72+COLLINS DEVELOPMENT

CITY OF MIAMI BEACH
DESIGN REVIEW BOARD

MARCH 2, 2021

72 COLLINS HOTEL & CONDOMINIUM
MIAMI BEACH, FL

EAST BUILDING ELEVATION - PHASE 1

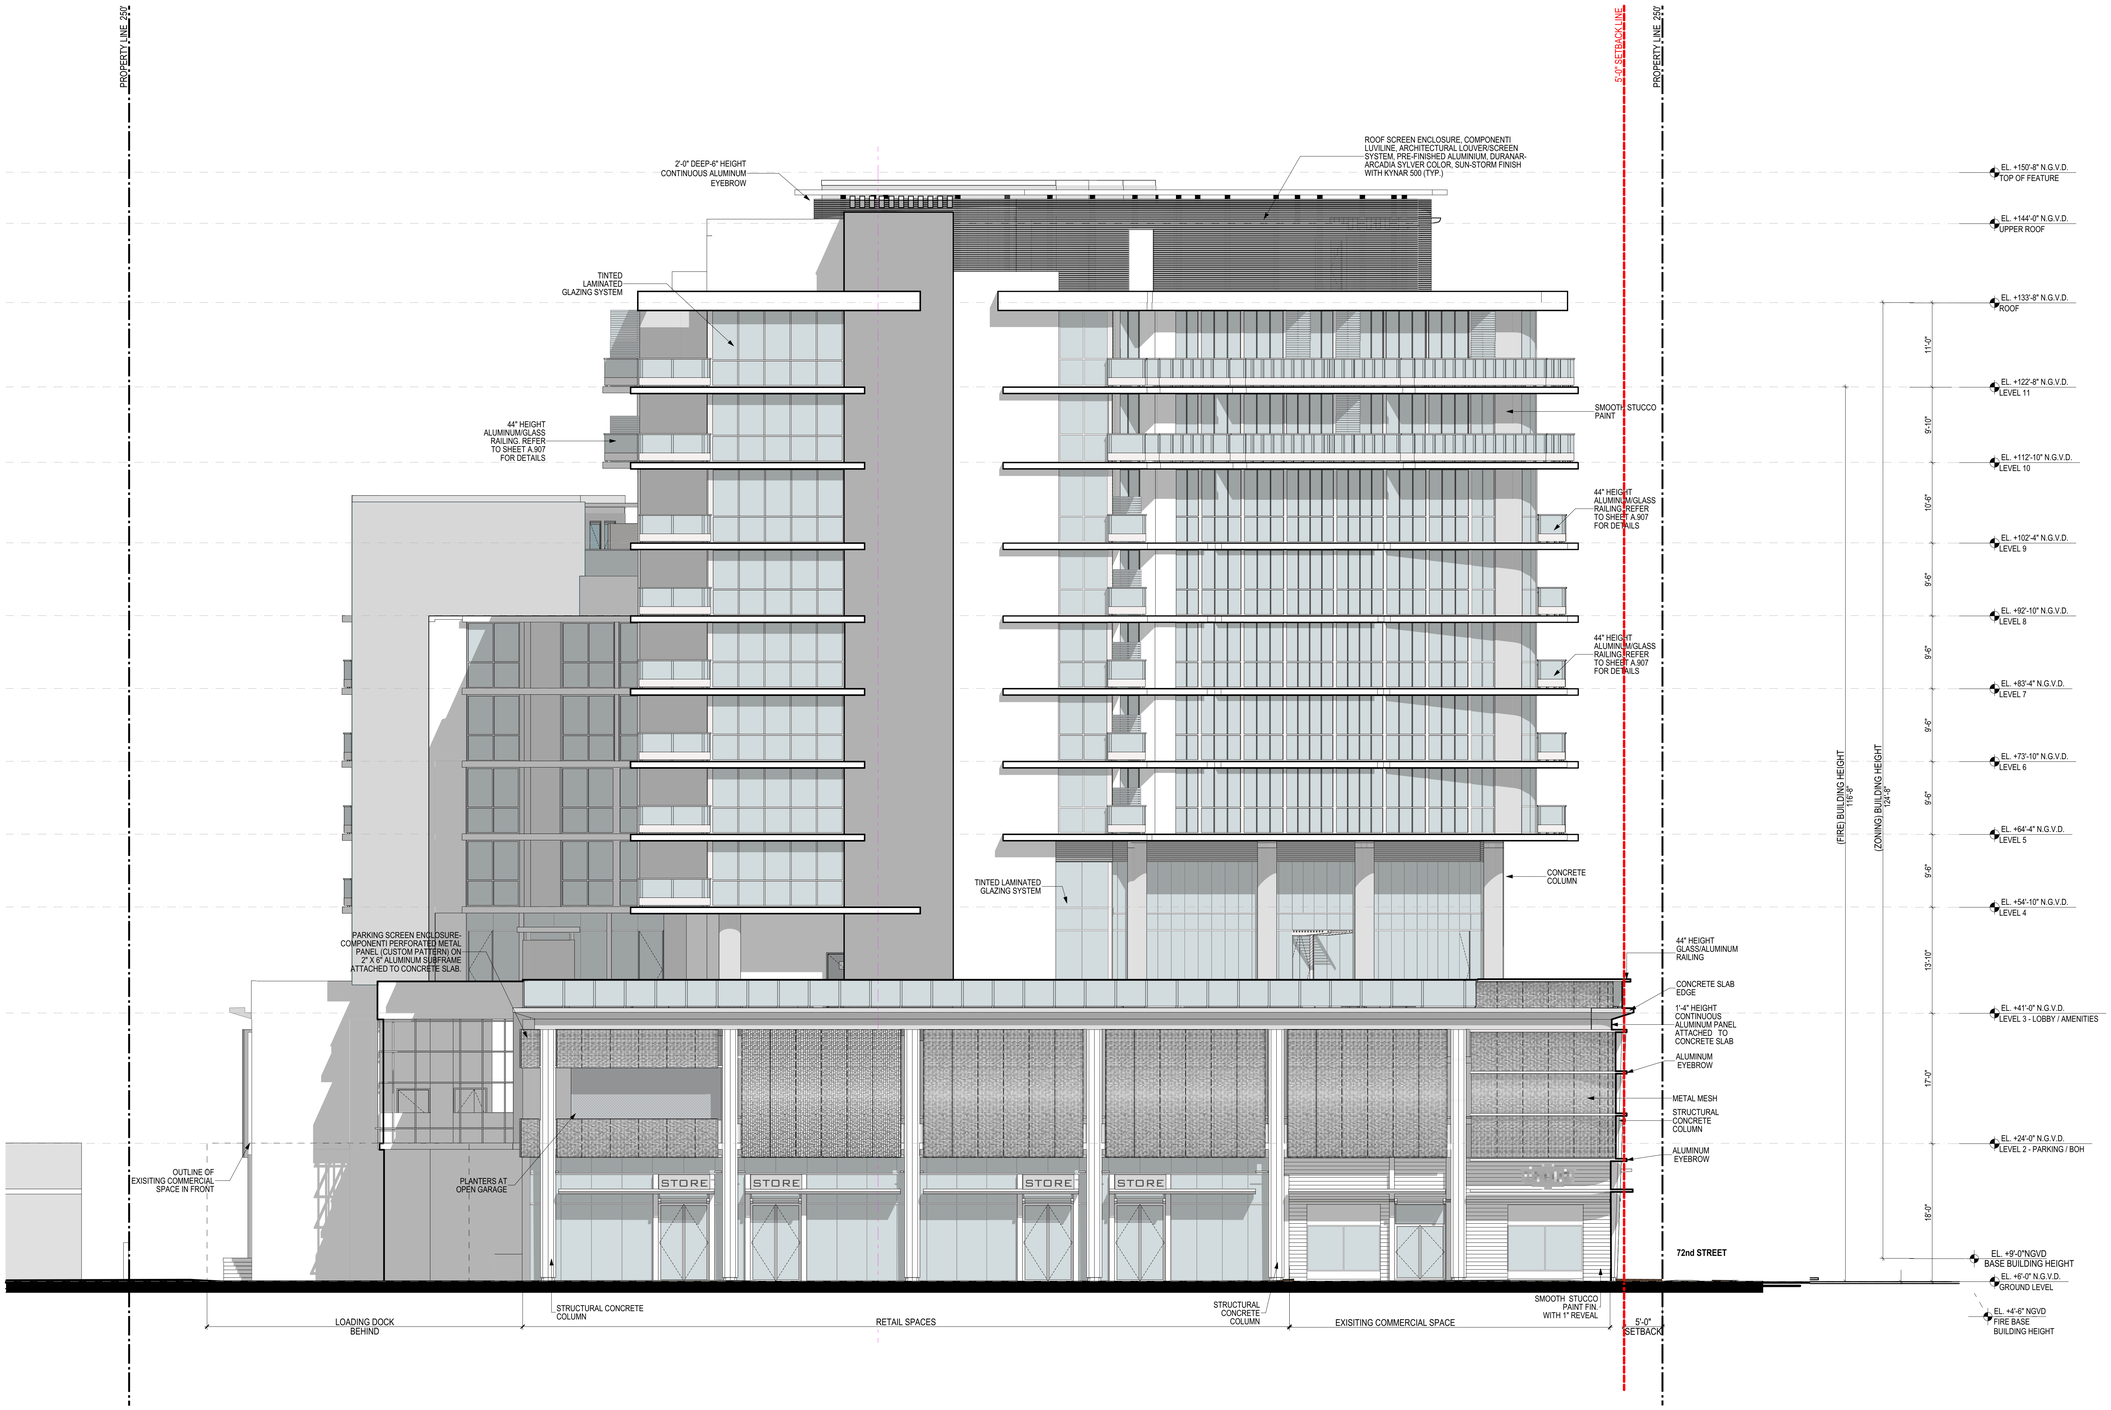
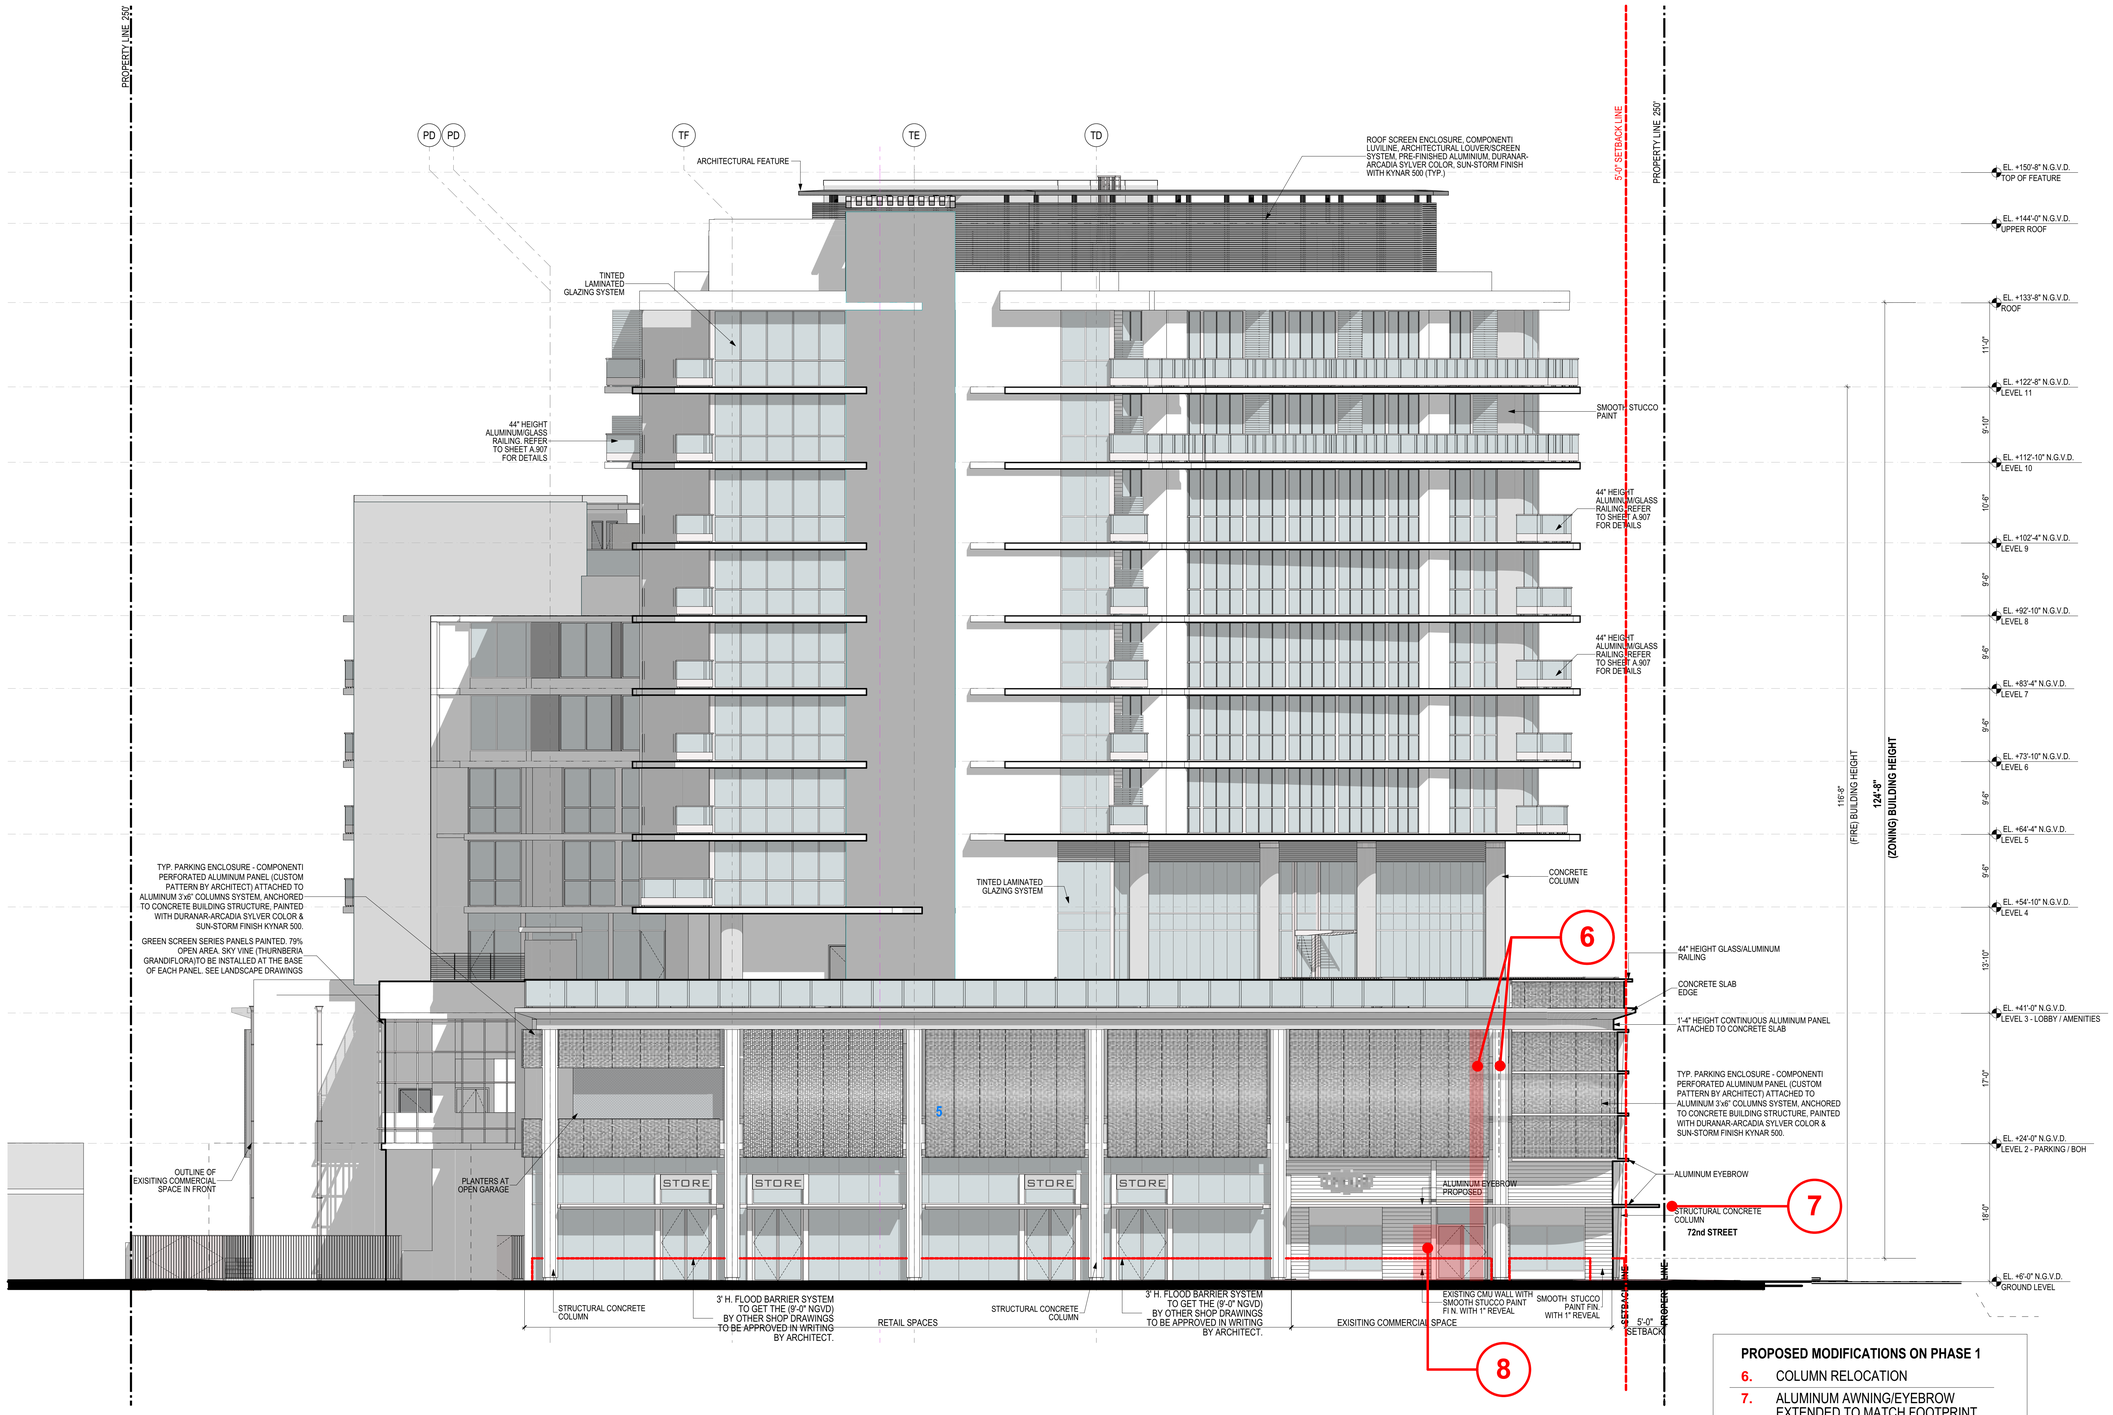
PROPOSED MODIFICATIONS ON PHASE 1

6.	COLUMN RELOCATION
7.	ALUMINUM AWNING/EYEBROW EXTENDED TO MATCH FOOTPRINT OF EXISTING CONSTRUCTED AWNING
8.	RETAIL DOOR RELOCATION

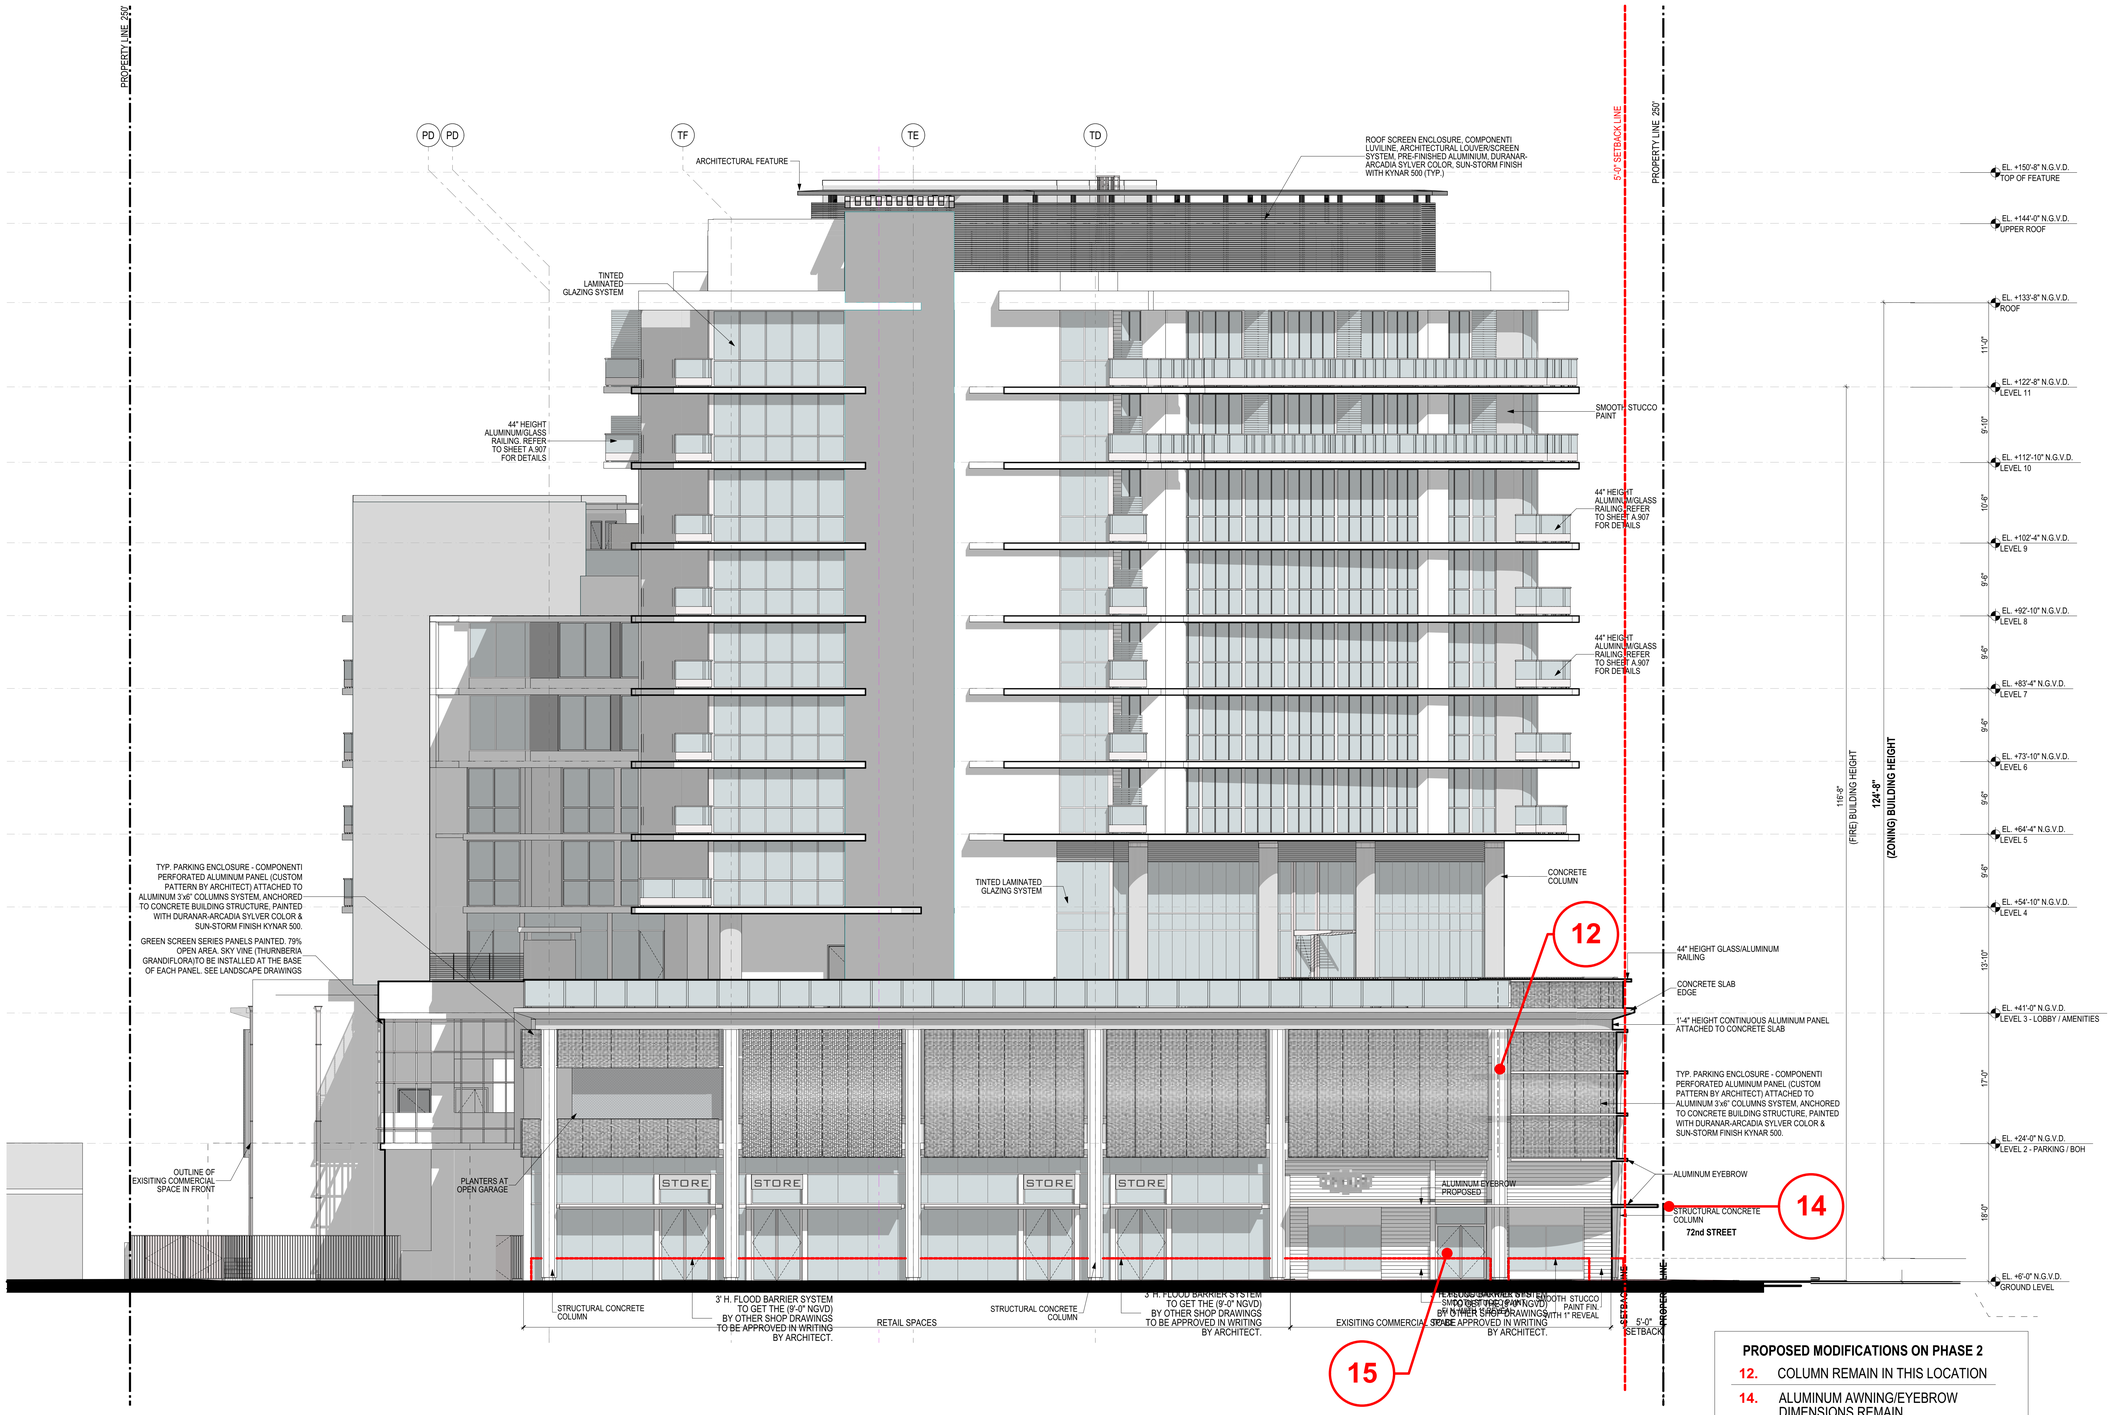
PROPOSED MODIFICATIONS ON PHASE 2

12.	COLUMN REMAIN IN THIS LOCATION
14.	ALUMINUM AWNING/EYEBROW DIMENSIONS REMAIN
15.	RELOCATION RETAIL DOOR
